SUBARU

PRODUCT CAMPAIGN BULLETIN

NUMBER: WQE-41
DATE: February 2013

SUBJECT: Optional Genuine Subaru Puddle Lights

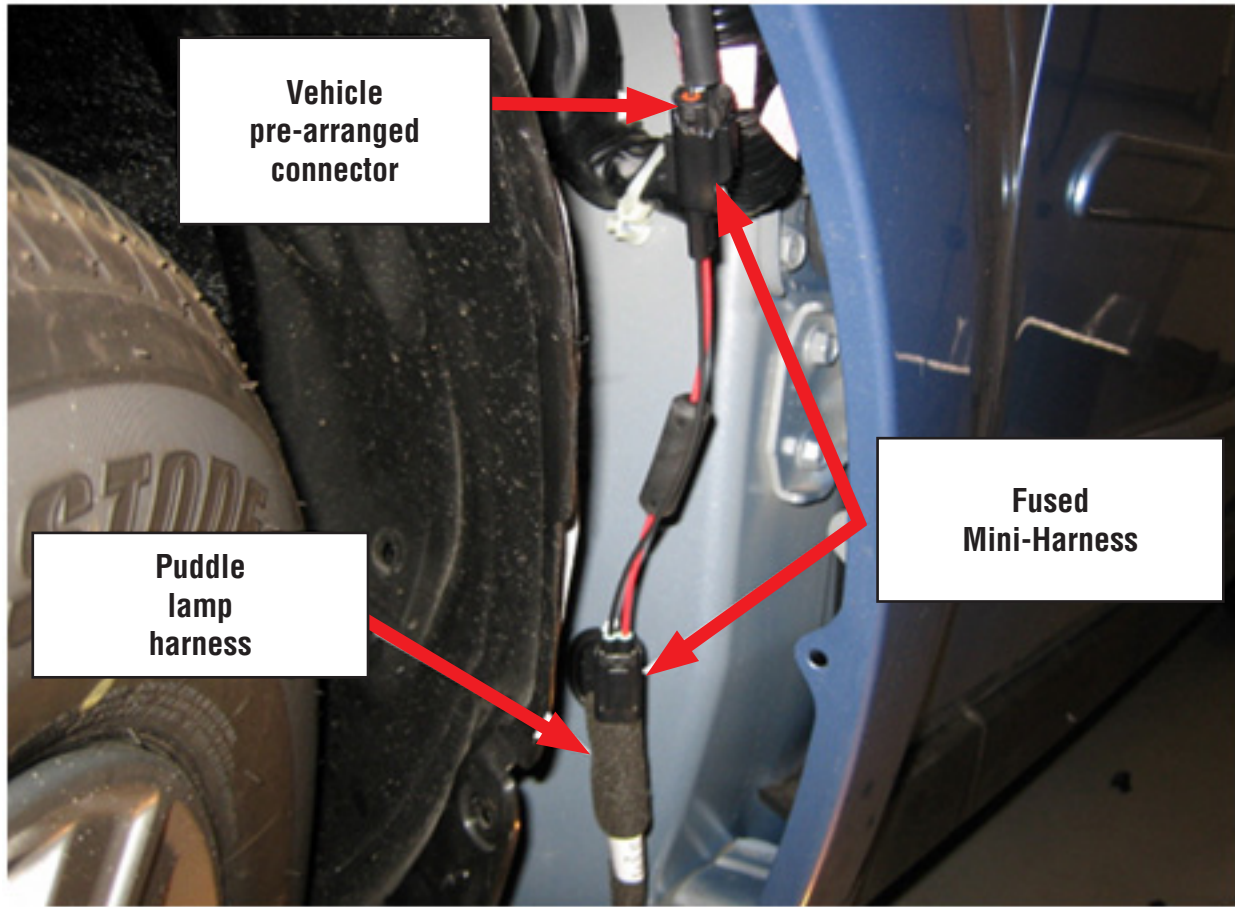
3. Once the splash shield has been moved enough for access, inspect the puddle light harnesses.
 - a. If the vehicle already has an in-line fuse in the red power wire within a few inches of the vehicle connector as shown in the photo below or a Fused Mini-Harness as shown in the photo on pg. 7 and both lights (all 4 LED bulbs) operate, no further action is required on that side.

- b. Next, check the other side of the vehicle starting again at Step 2. Once inspection of both sides of the vehicle is complete and fuses are confirmed to be on **BOTH** sides of the vehicle, proceed to Step 5, otherwise see “c” below.
- c. If no in-line fuse or Fused Mini-Harness is present, unplug the puddle light harness connector from the vehicle body harness connector and install the Fused Mini-Harness as shown in the reference photos below.
